Modification Notice – Type II Van cable anchored seat buckle end.
We are requesting that you replace the cable style buckle with the web strap assembly provided.

Modification Notice – Type II van cable anchored seat buckle end.

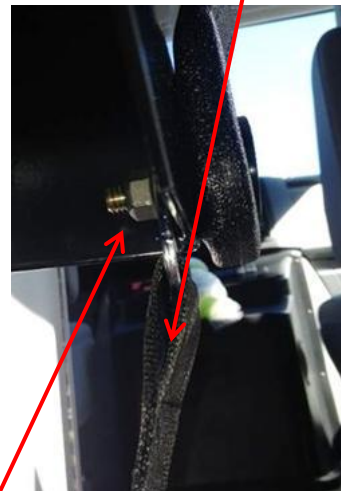
The three pictures below show a **Pedestal Style Base** which utilizes a Tether Strap attached to the Base. (See pictures below) This tether must be re-attached when replacing the cable style buckle end. After removing the installation bolt and the cable buckle end, re-attach the provided new webbed buckle using the flat washer and the connecting bracket for the Tether Strap. Both pieces will assemble behind the base with the installation nut. (NOTE) – When using a stover type prevailing torque nut and bolt please ensure the nut is completely seated prior to applying 28-32 foot pounds or torque. Please discard the old cable style buckle.
